North Anna 3 COLA

FSAR Sections 3.7 and 3.8 Seismic
Structural Analyses
May 22, 2014 Meeting with NRC

RB/FB Lumped Mass Stick Model Properties

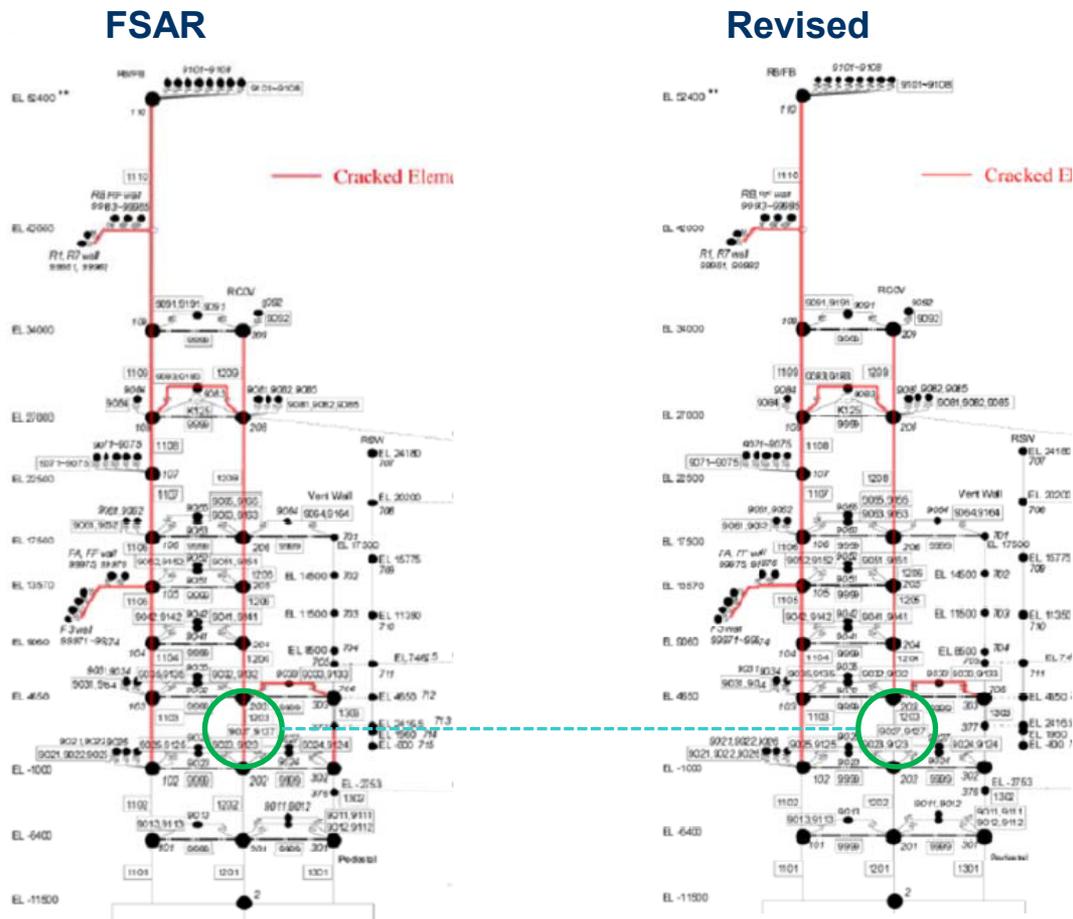
- Figure 3.7.2-210: Changes made to Stick members properties

- Stiffness and damping properties assigned to reinforced concrete members are based on stress results from SSI analysis for BE subgrade profiles
 - 50% reduced stiffness and SSE damping used for stick and exterior wall shell elements if in-plane shear stress exceeds concrete rupture stress of $3\sqrt{f'_c}$ psi
 - 50% reduced stiffness and SSE damping used for oscillators, stick and outer wall shell elements if out-of-plane bending stress exceeds cracking criteria of ACI 349-01, Section 9.5.2.3
- In-plane cracking evaluated based on shear stresses calculated using effective stick member shear area equal to:
 - 60% of actual area of shear walls in particular direction (per ASCE 43-05 Section 4.2.3)
 - 50% of total axial area of circular cross sections

Revised Methodology for ISRS Development

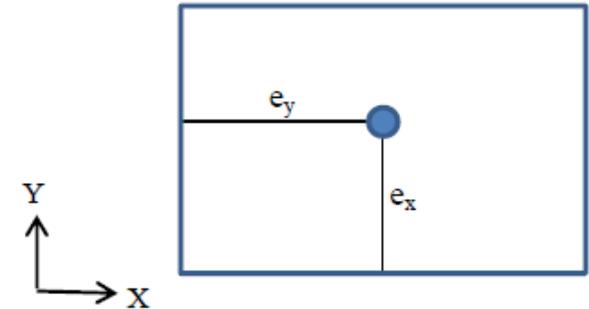
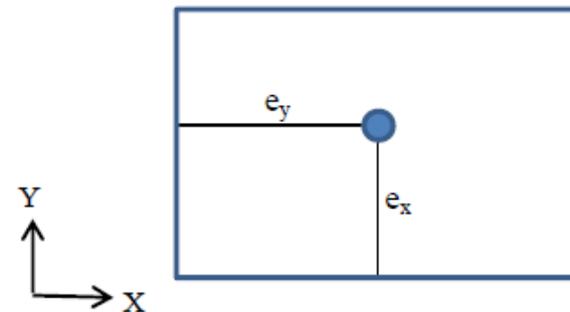
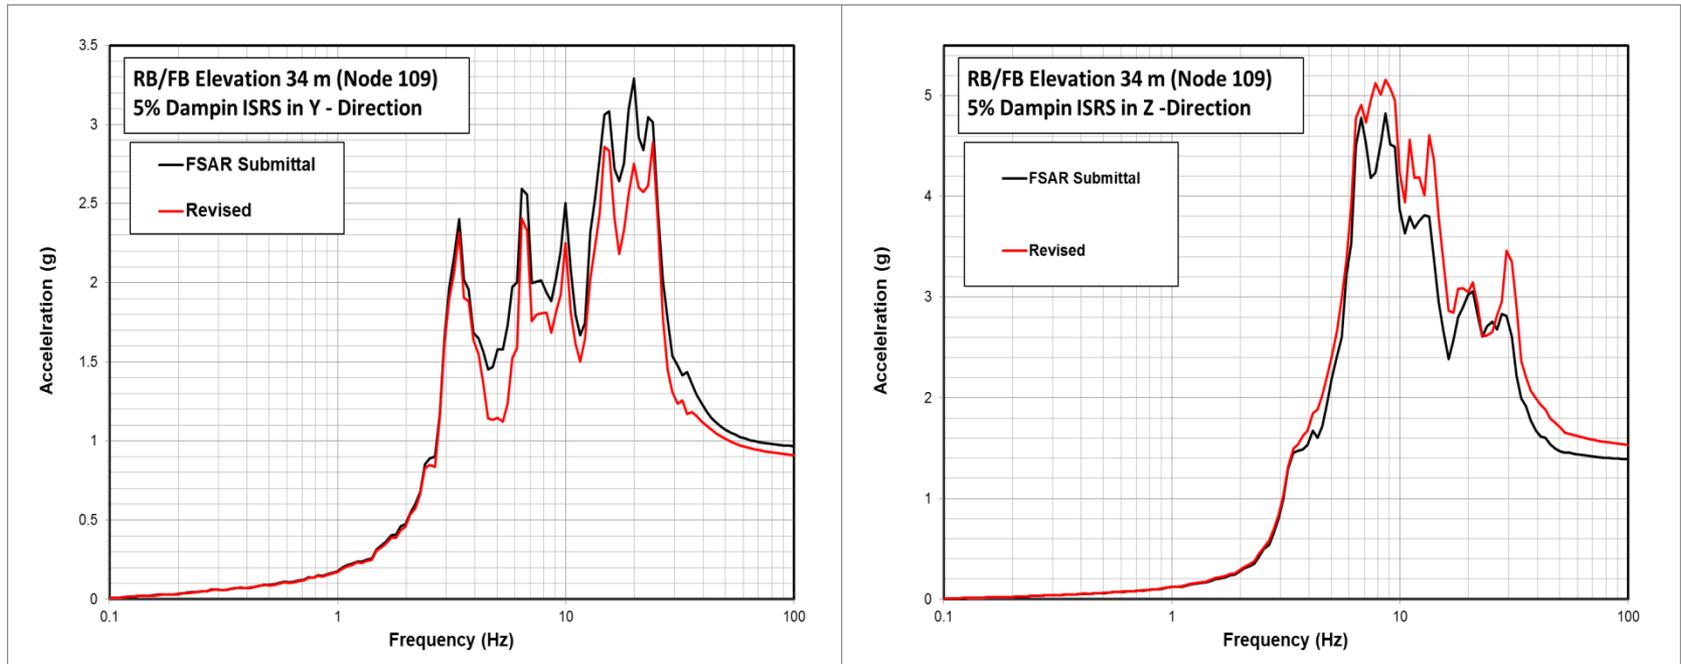
- ISRS in FSAR submitted December 2013 were developed by combining spectra of translational and rotational response using:

In FSAR markup submitted May 2014, ISRS are developed using revised methodology where translational and rotational response of floor mass are combined in time domain to obtain responses at four floor corners

Revision of methodology for ISRS development resulted in slightly lower horizontal ISRS and vertical ISRS with larger amplitudes (Figures 3.7.2-211 to 282)

Corrections to FWSC Sliding Stability Evaluation

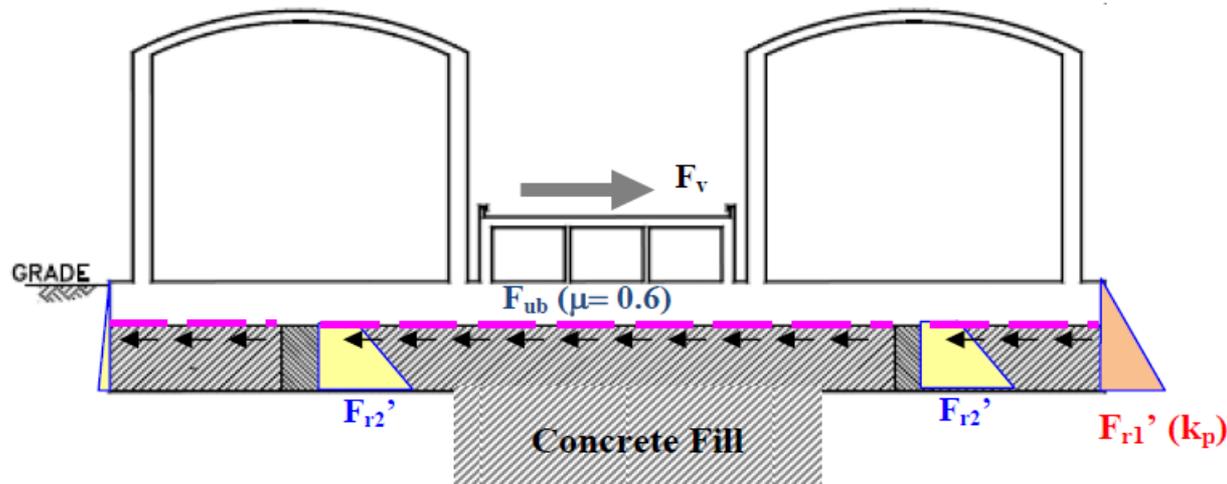
- In FSAR submitted December 2013, following lateral resistance forces were considered:
 - F_{ub} - base friction resistance at foundation-concrete fill interface
 - F_{r2}' - bearing pressure resistance on face of shear keys embedded in concrete fill
 - F_{r1}' - bearing pressure resistance on sides of foundation embedded in engineered fill

- Incorrect assumption was made, that lateral displacements were sufficiently large to engage passive resistance of engineered fill surrounding FWSC foundation

- Due to high stiffness of concrete fill, amplitudes of lateral deformations of FWSC shear keys and foundation are small and insufficient to engage passive resistance of soft engineered fill
- In FSAR markup provided May 2014, FWSC sliding stability completely neglects lateral resistance of engineered fill F_{r1}
- Results of re-evaluation show that correction made to calculations of engineered fill resistance do not affect results and conclusion of FWSC sliding evaluation
- Only description of FWSC sliding stability evaluation in FSAR is revised

Transfer Functions Amplitudes for RB/FB Refueling Floor Response - BE Case

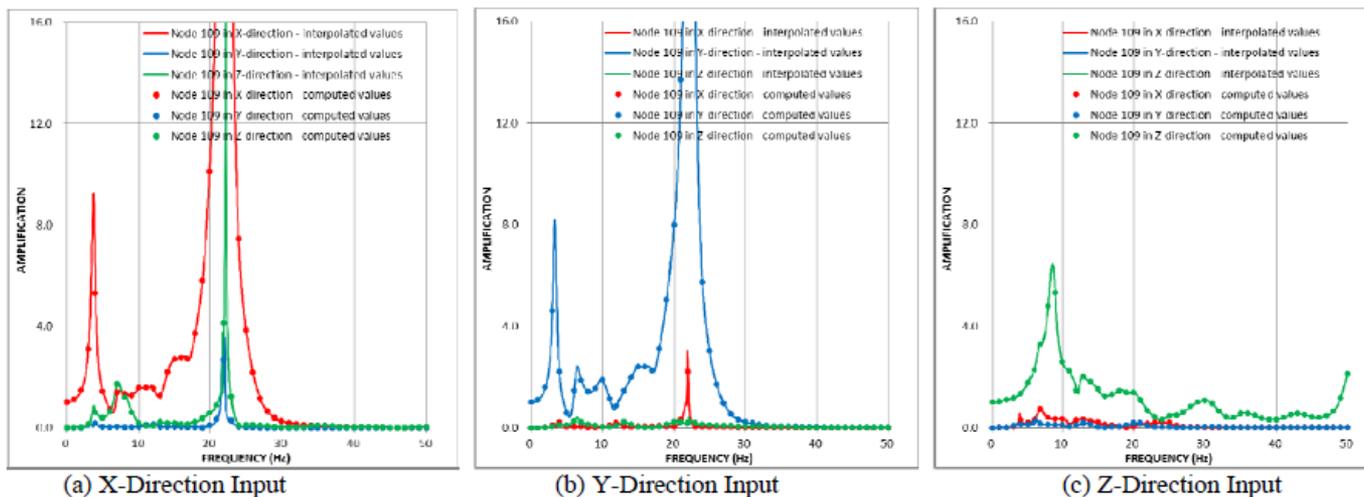
Provide transfer function results for responses at key locations from site-specific SSI analyses of RB/FB, CB and FWSC for all soil cases

- Technical reports available for audit provide plots of transfer function results from site-specific SSI analyses for responses at RB/FB, CB and FWSC key locations
- For each subgrade profile analyzed, plots are presented to show both calculated values (dots) and interpolated values (curves) of transfer function amplitudes for translations in 3 orthogonal directions due to 3 earthquake components

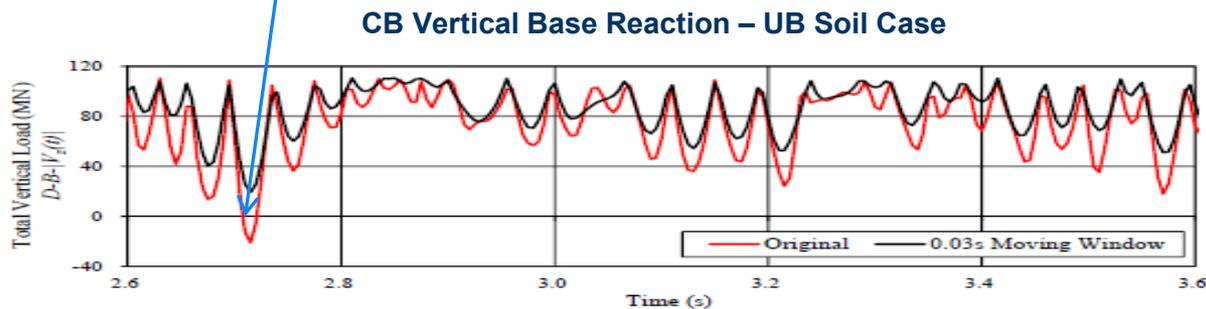
- (a) Explain reason for using moving average window and its impact on sliding stability evaluation results
- (b) Clarify how sliding stability is evaluated
- (c) Provide technical basis for using value of 0.6 static coefficient of friction and explain if reinforcement is needed at concrete fill interfaces
- (d) Provide description and magnitude of all lateral resisting forces
- (e) Provide allowable bearing pressures for embedment and magnitude of deformations to justify use of static friction resistance
- (f) Provide results of shear key evaluations

- (a) There are a few short instances of time when CB base is not in contact with subgrade shown as spurious peaks in base reaction time history

Moving average window filters out high frequency content from base reaction time histories that produces short duration effects leaving low frequency content that governs global motion and seismic stability of building
